ALDERETE COURT

ENGINEER'S SEAL	LOT 18, BLOCK 8, UNIT 22 VOLCANO CLIFFS	DRAWN BY JDG
DAVID SOULE NEW MEXICO REGISTERED PROFESSIONAL ENGINEER 14522	GRADING AND DRAINAGE PLAN	DATE 03-21-2017
3/21/17	Rio Grande Engineering 1606 CENTRAL AVENUE SE SUITE 201 ALBUQUERQUE, NM 87106 (505) 872-0999	SHEET # 1 OF 1
DAVID SOULE P.E. #14522		JOB #

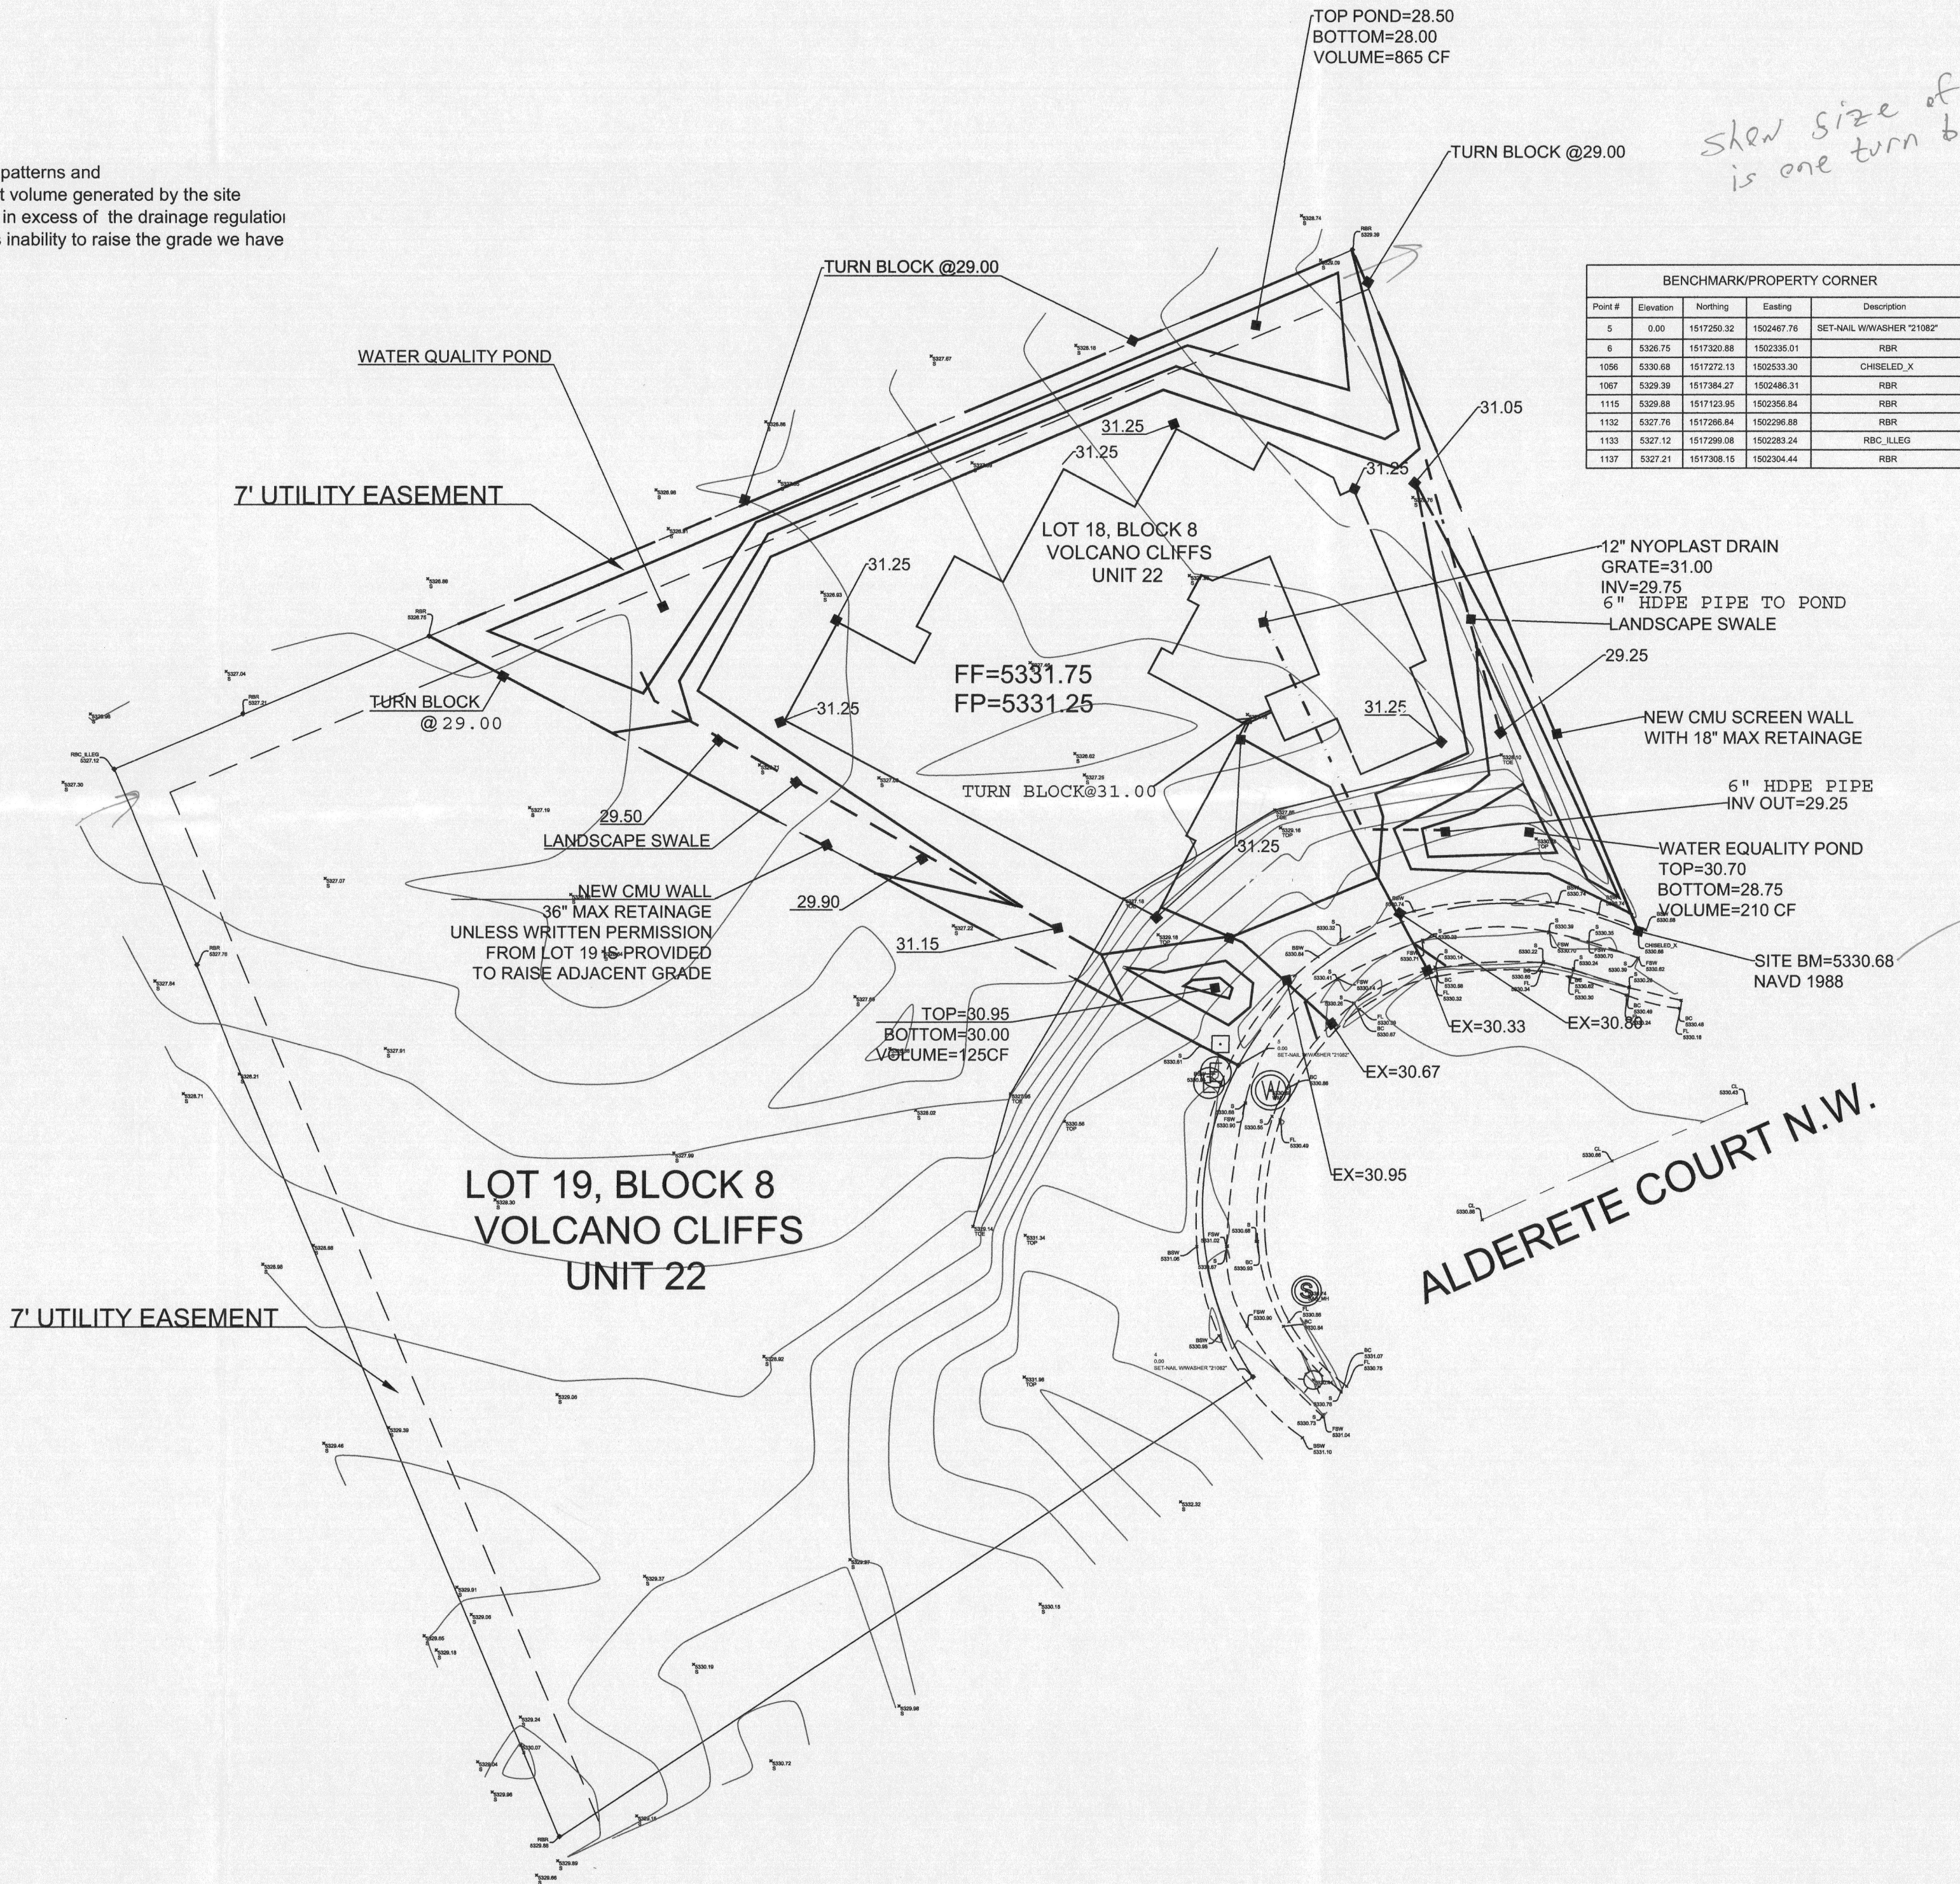
Pad cert statement
